Updated: November 2, 2021

RE: RE-ZONING AND DEVELOPMENT PERMIT APPLICATION: 1042-1044 RICHARDSON STREET

PLANNING STAFF REVIEW: APRIL 18, 2021

Figure 1: Typical bedroom elevation – North and East Elevations

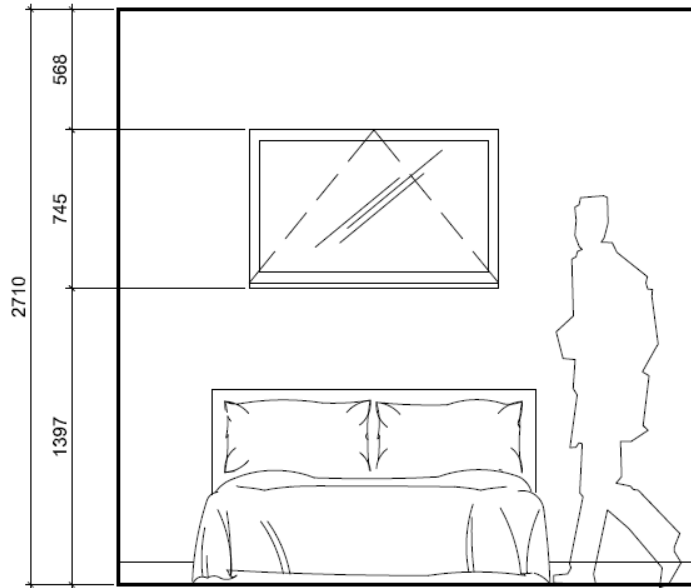
- **Condition #3:** *The proposal is inconsistent with the form and character objectives for Urban Residential Areas contained in the Fairfield Neighbourhood Plan (see 8.8)*
 - *new development should be neighbourly, compatible and transitions sensitively to adjacent development;*
 - *minimize the impacts of off-street parking on the quality of site designs. Vehicle parking should be located underground;*
 - *include landscape and on-site open spaces that contribute to urban forest objectives, provide environmental benefits, and support sociability and livability. Useable at-grade open space is encouraged.*

- Window placements were designed to avoid overlook, as shown in the window overlay. The overwhelming majority of windows facing neighbouring properties are not designed to provide views, but rather airflow and natural light, being placed high in bedrooms (not principal living rooms). See **Figure 1**, which provided an illustration of most windows on the North and East Elevations in the plans.

- Balcony locations were carefully considered in design (see explanations for each elevation):
 - North:** There is only one set of Juliet balconies placed to the north (facing towards 1035 McClure St.), providing continuity with the overall design on the north facade of the building. Importantly, these windows are placed in the bedroom of the 1-bedroom units, not the principal living spaces. All other windows facing north are placed high in the rooms to provide light and airflow, but not facilitate overlook (as per **Figure 1**).

1 Solar Study - Vernal 9am
1 : 500

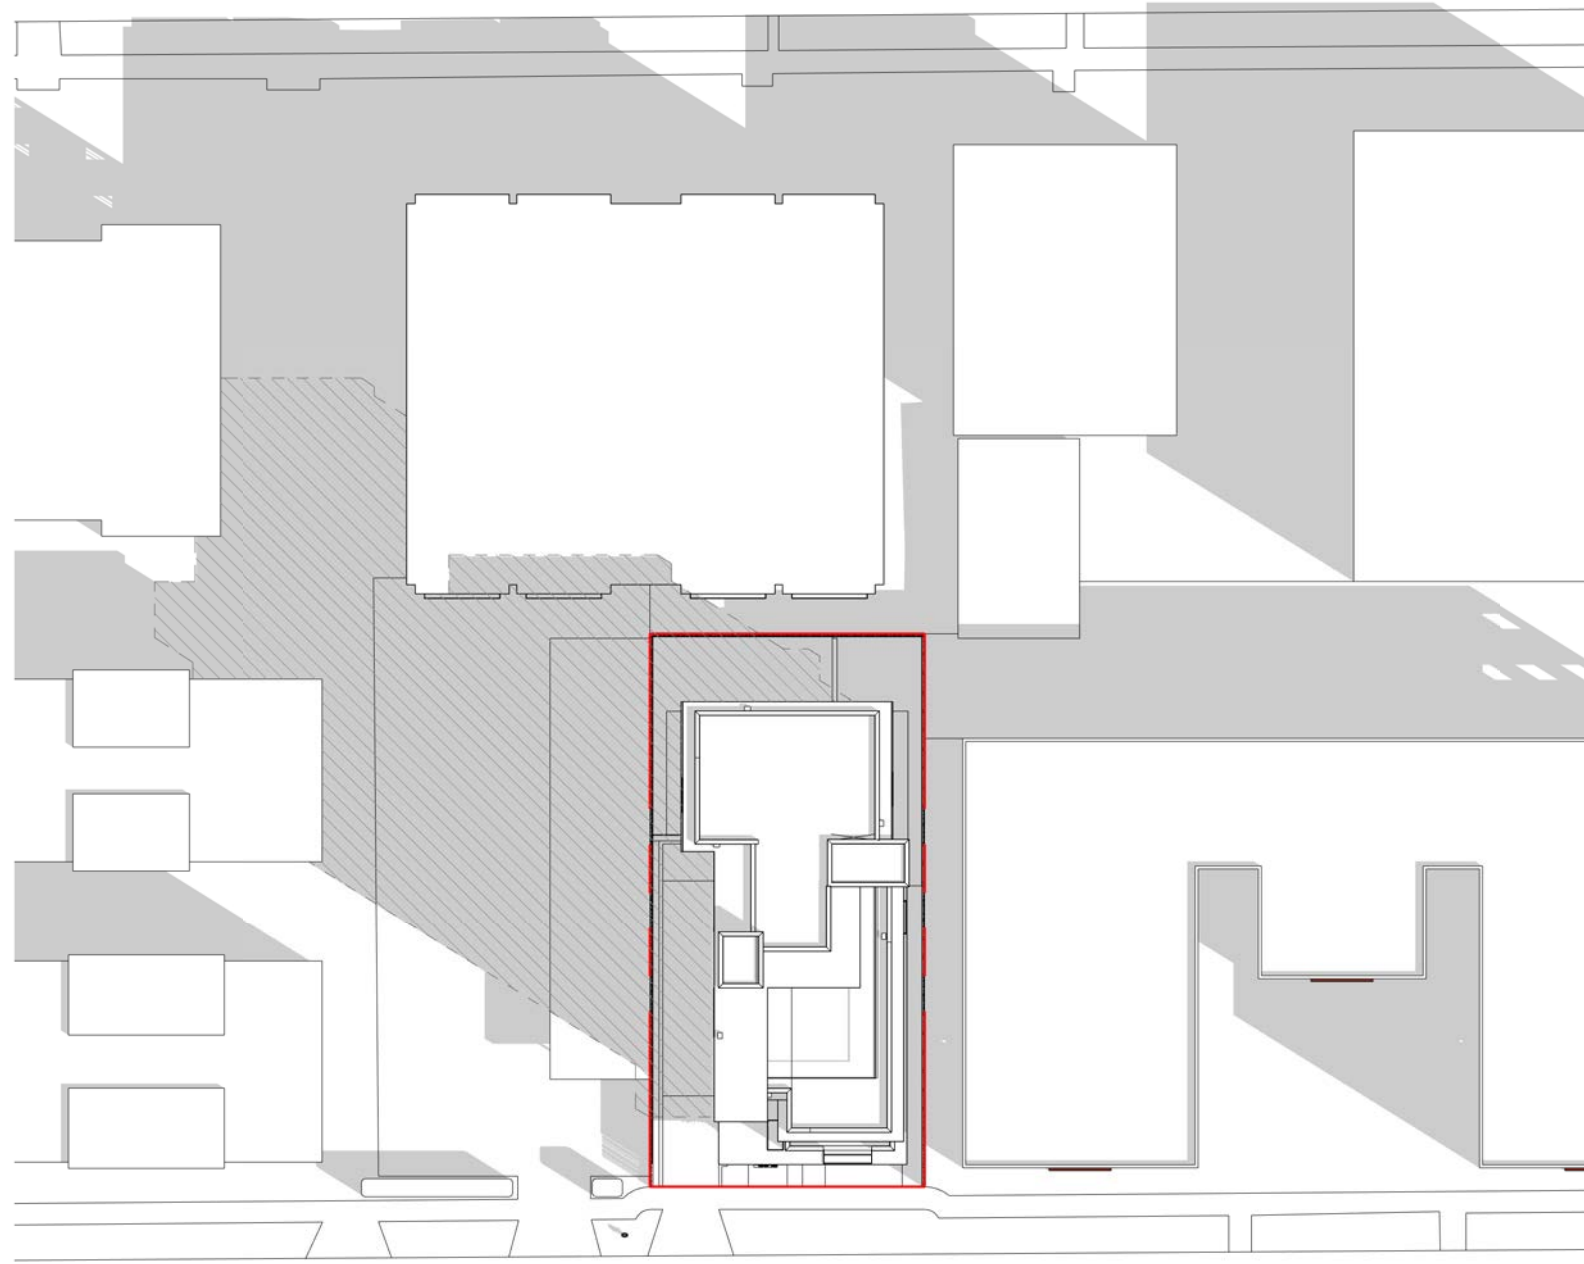
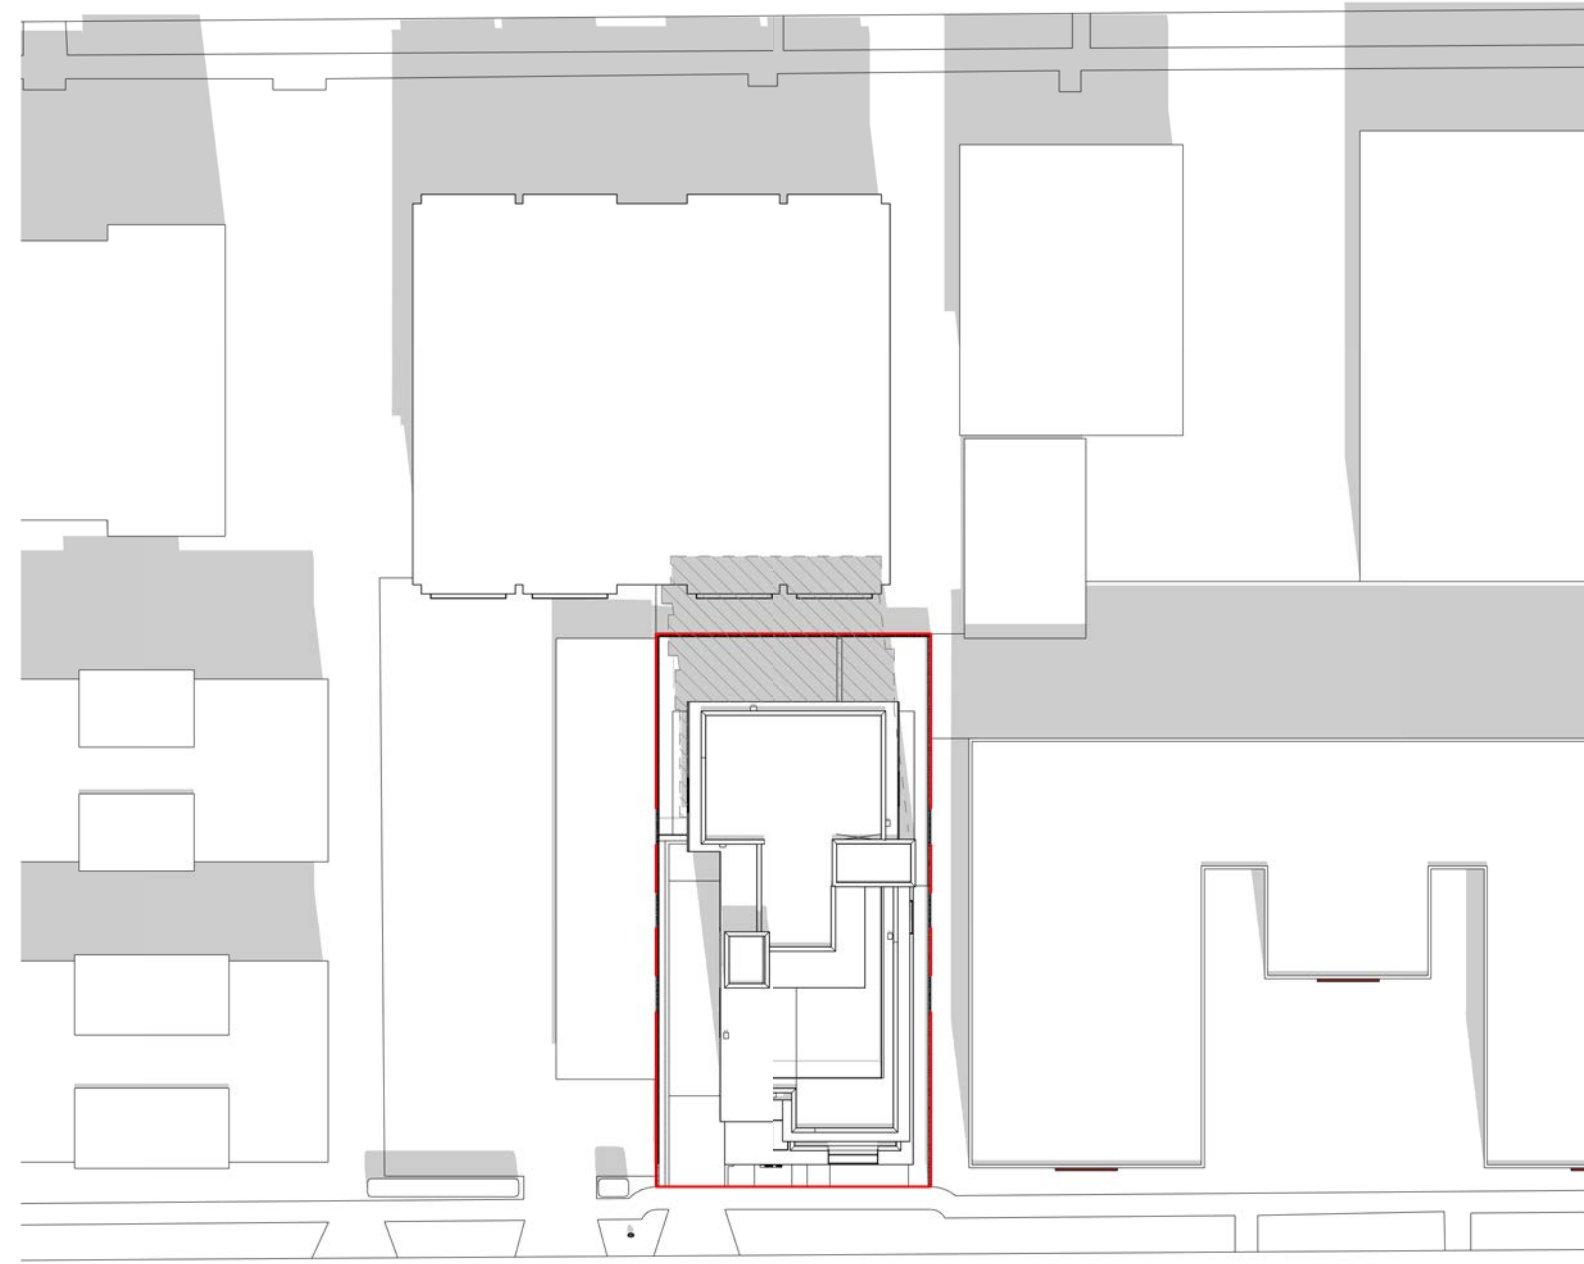
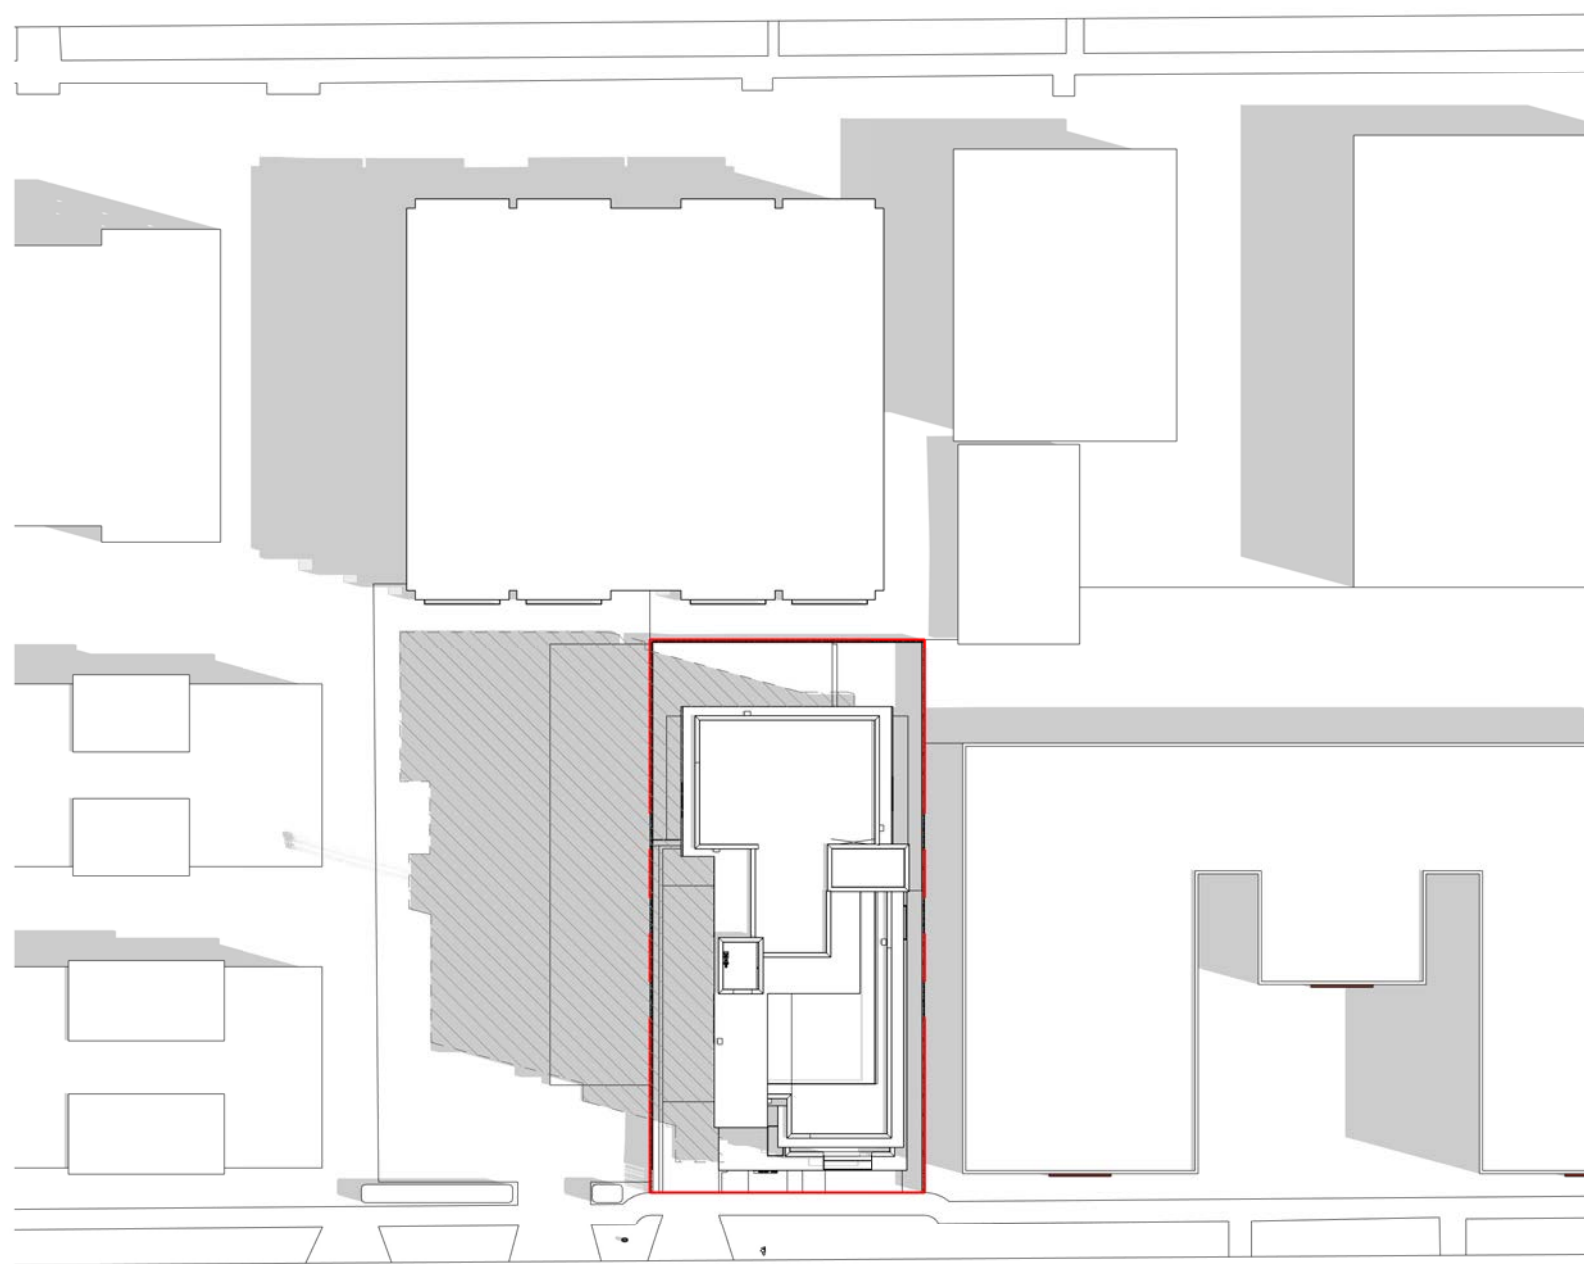
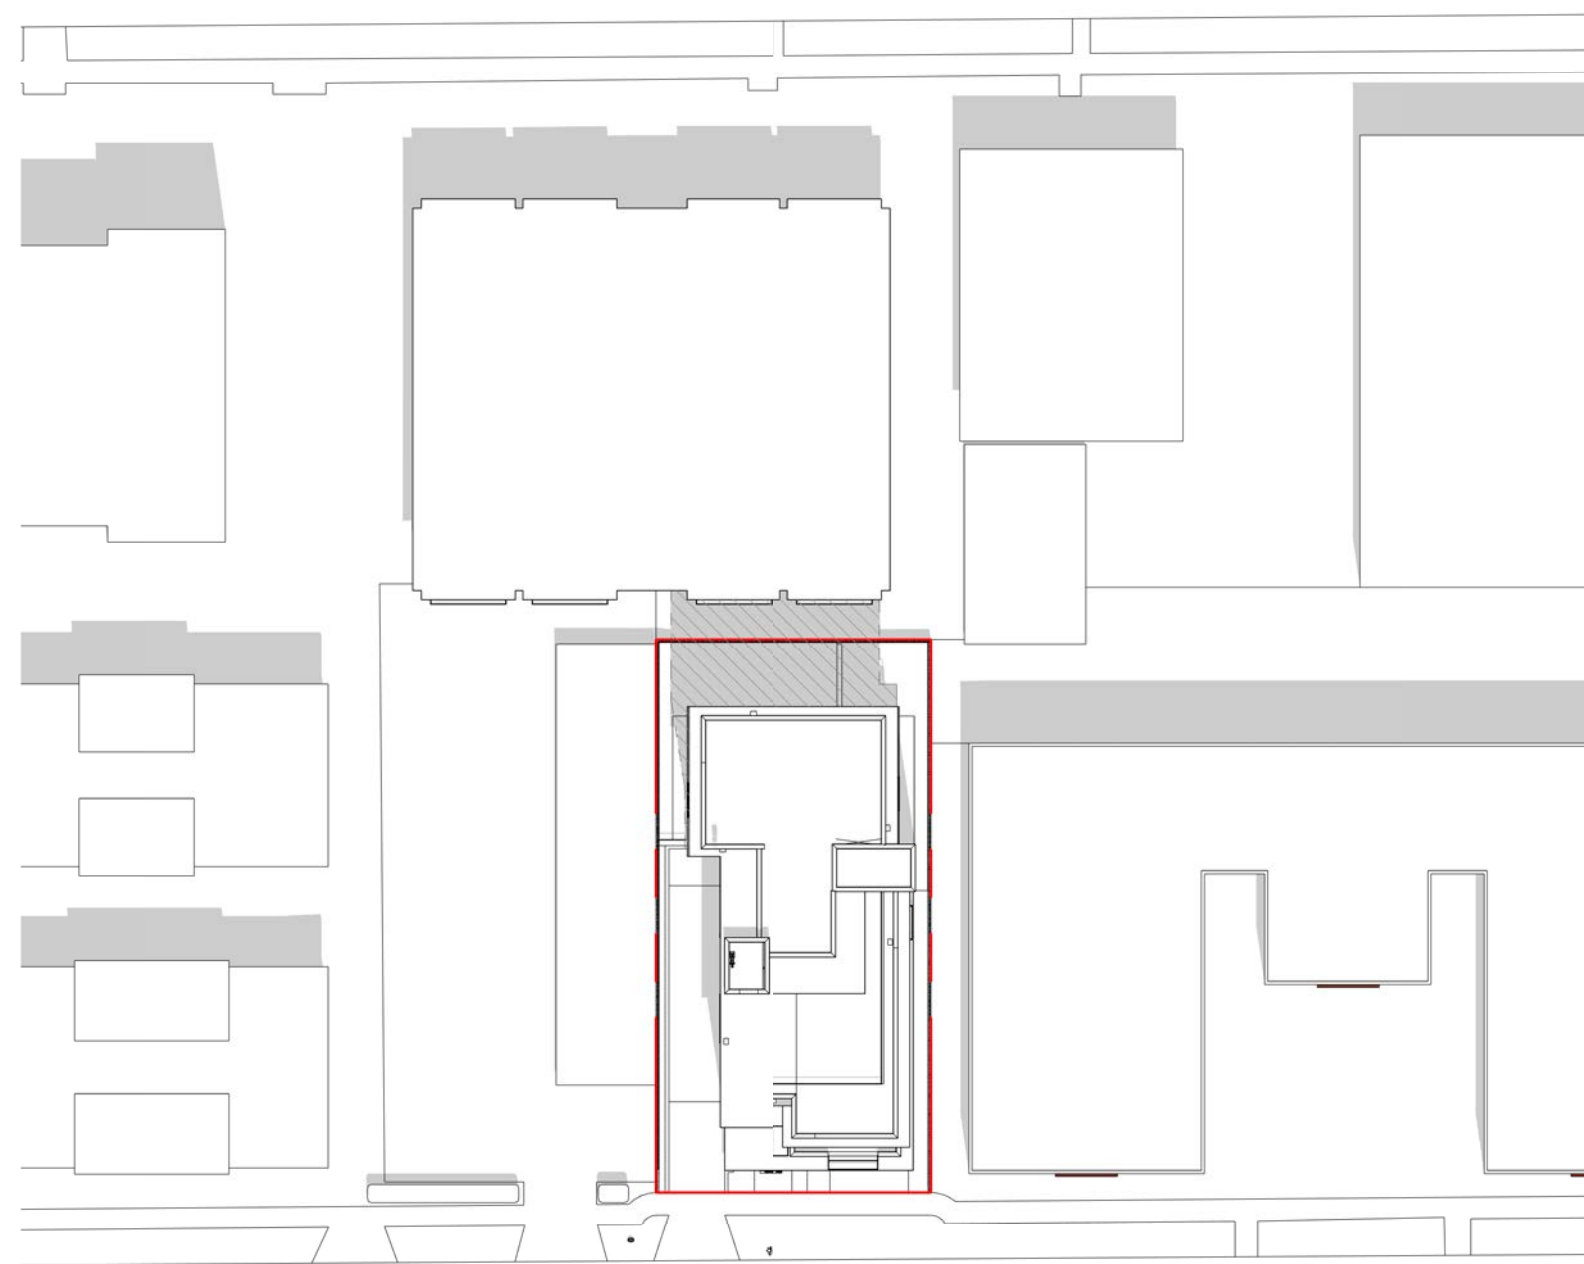
Condition #4: *Please provide a 3D shadow analysis to help assess the shadowing impacts of the proposed building.*

Applicant Response / Actions Taken: A 3D shadow analysis has been completed and is included in the revised plan set. Placing the roof deck centered on the rooftop, and away from the northern property line, reduces shadowing impacts on neighbouring properties.
